Construction Division
Additions & Alteration Charges Approval Form

Company Name:	Modi Properties Pvt Ltd	Site	May Flower Platinum
Name of the customer	ANIL KUMAR / ARUPALA SPORTS		
Villa/ Flat No.	C - 105		
Sl.No	Description	Amount	
1	Total extra Charges	27,690 = 00	
2	Total refundable amount	6,919 = 00	
3	Net amount to be charges (if any)	20,771 = 00	
4	Net amount to be refunded (if any)	-	
Remarks :			
Approved by Project Manager		Approved by Design Team	
Date		Date	
Sign:		Sign:

Details of Additions & Alterations

Flat No	105	Block	'C'
Flat Area	1800 sft	Type	Deluxe / Luxury
Buyer Name	ANIL KUMAR/MRUDULA SPURTHI		
Phone No.	8499994767 8978481877	Email	chaitu011@gmail.com.

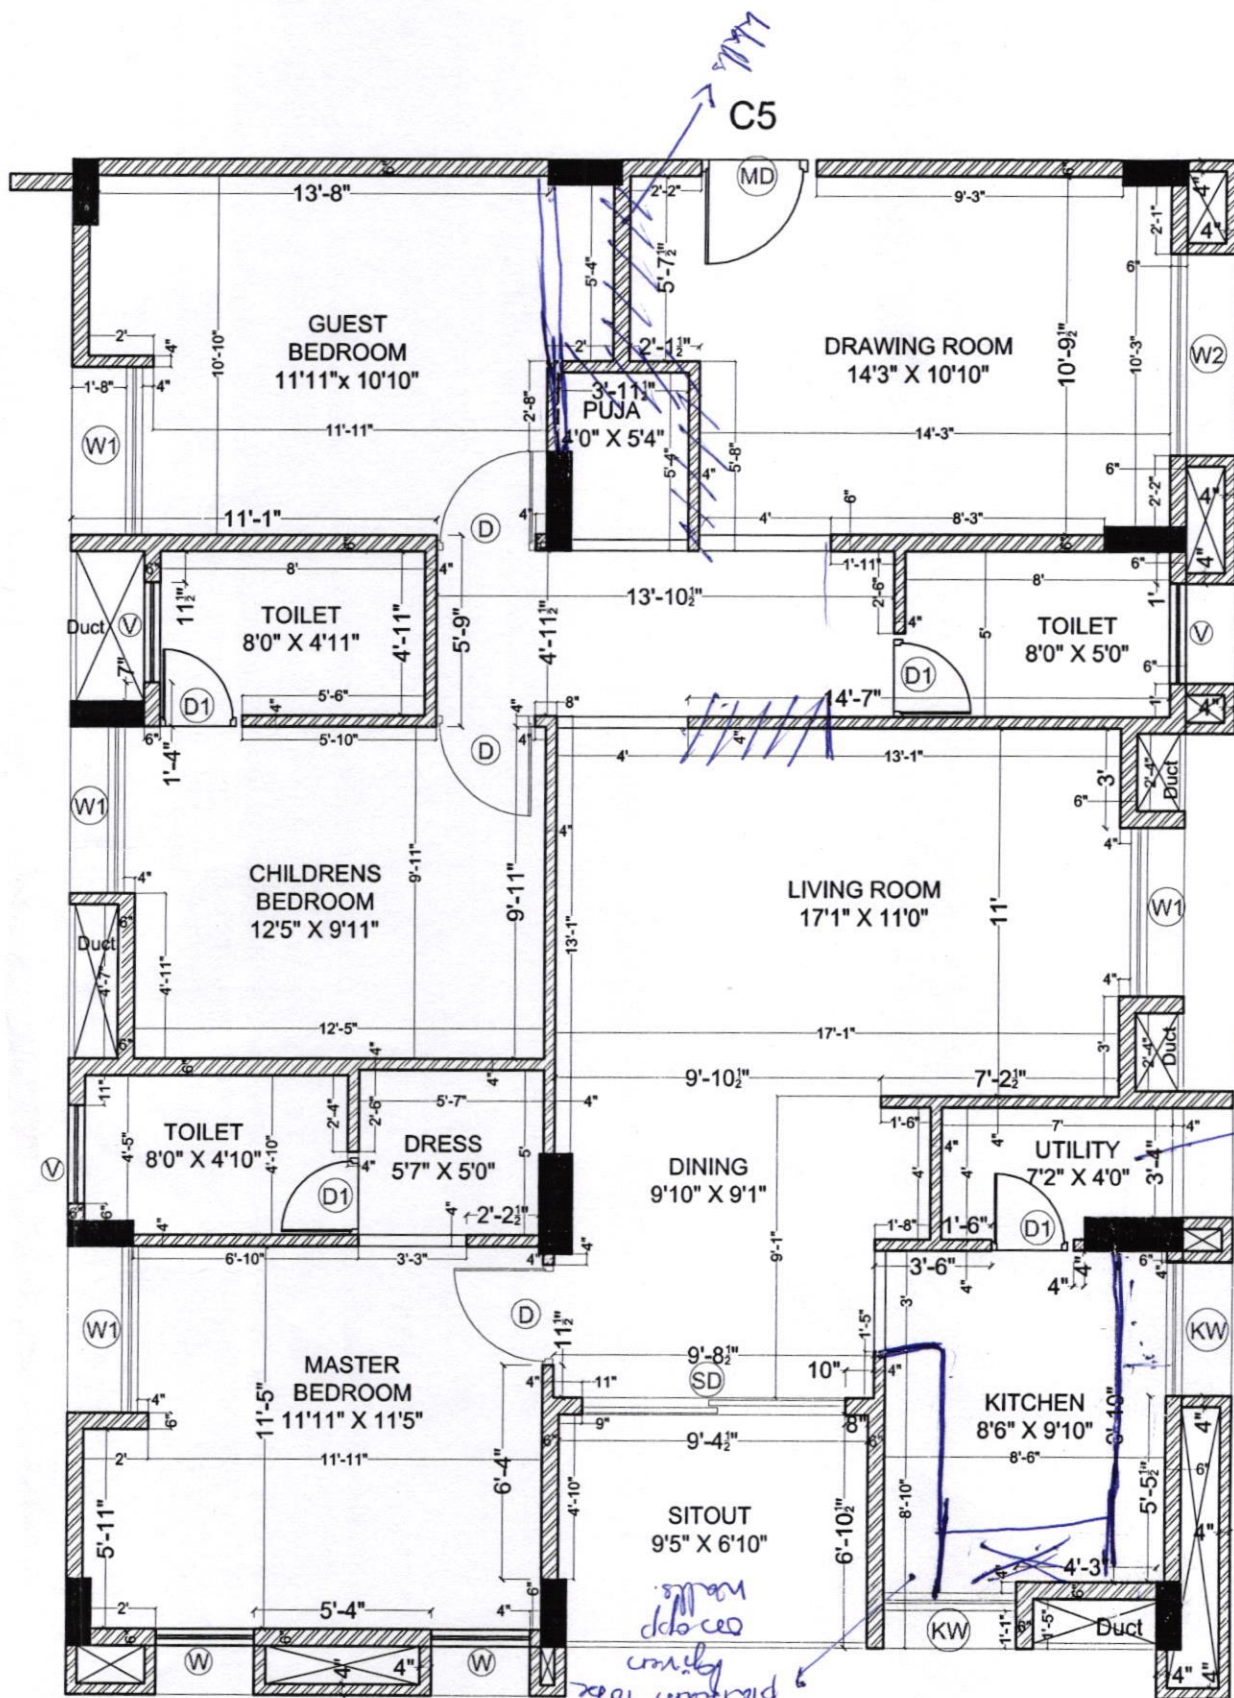
Changes in kitchen platform: (mark on plan)

- 1) Kitchen platform to be given on opp. walls as marked till edge of the wall.
 - 2) Kitchen granite & tiles broker by customer.
 - 3) Kitchen sink purchased by customer and informed to management on the same day as granite.
- Informed on 23rd May 2022. *Agarwal*

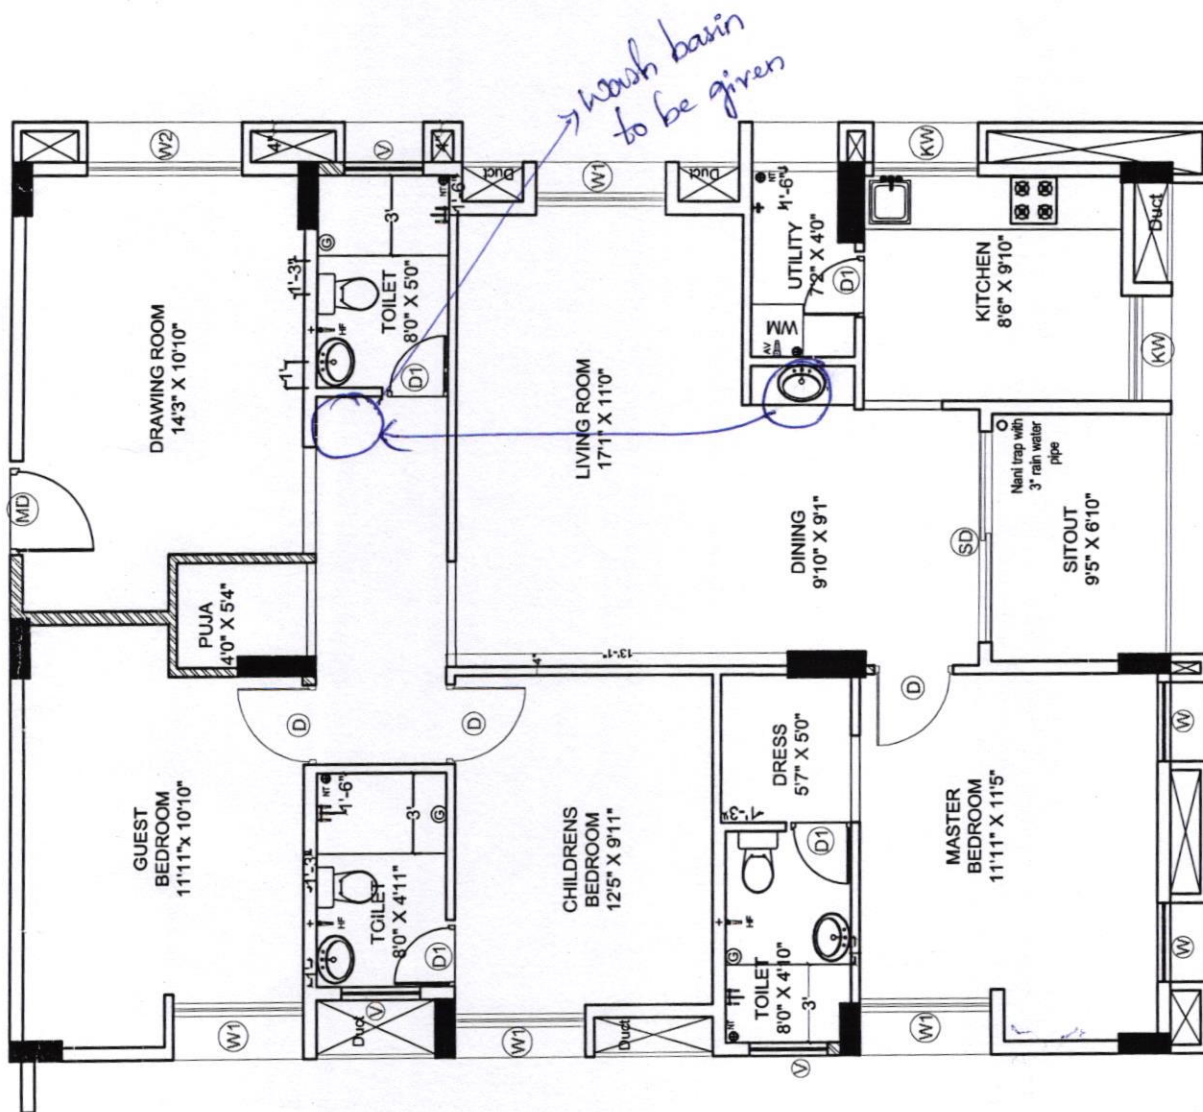
Other Changes:

- 1) Puga room to be removed as marked.
- 2) Wall at living room as marked to be removed.
- 3) Utility washing machine platform to be flat. (No platform).
- 4) All windows to be 3 track & to be provided with mesh.

(Platform)
to be removed

Description	Direction	Owners & Developers :	Date :	18.08.2020	Promoted by
WORKING DRAWING OF FLAT.NO.C-5		Modi Properties Pvt Ltd.	Prepared By :		Modi Properties Pvt. Ltd Phone:+91-40-66335551
		Project Name & Phase :	Approved By :	Soham Modi	
		MAYFLOWR PLATINUM	Scale :	N.T.S

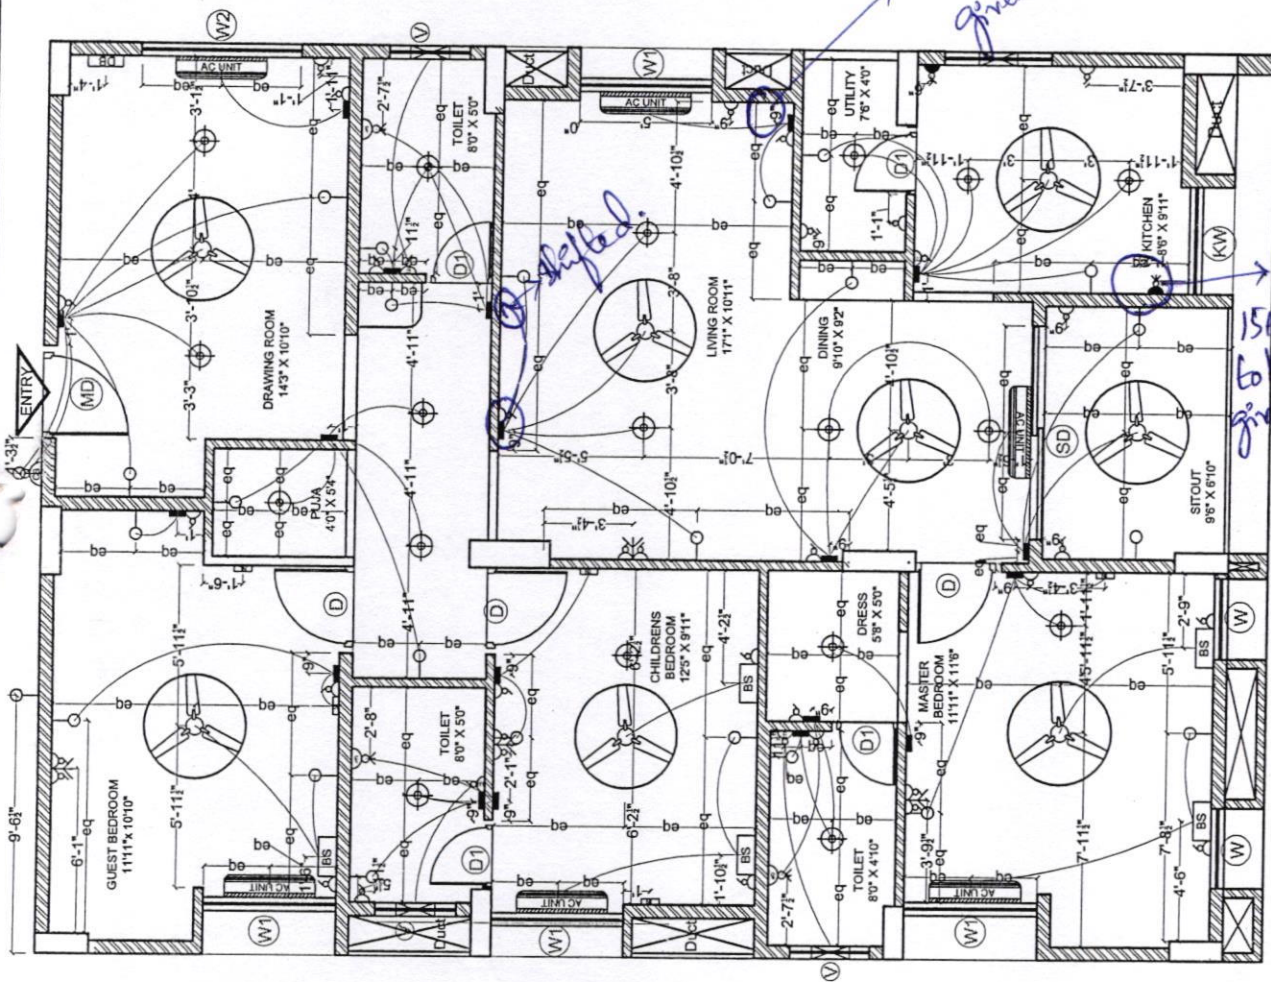
Changes in electrical points: (mark on plan)

- 1) SA to be given in living room as marked
- 2) Controller to be shifted in living room.
- 3) Tolia SA to be given in kitchen as marked.
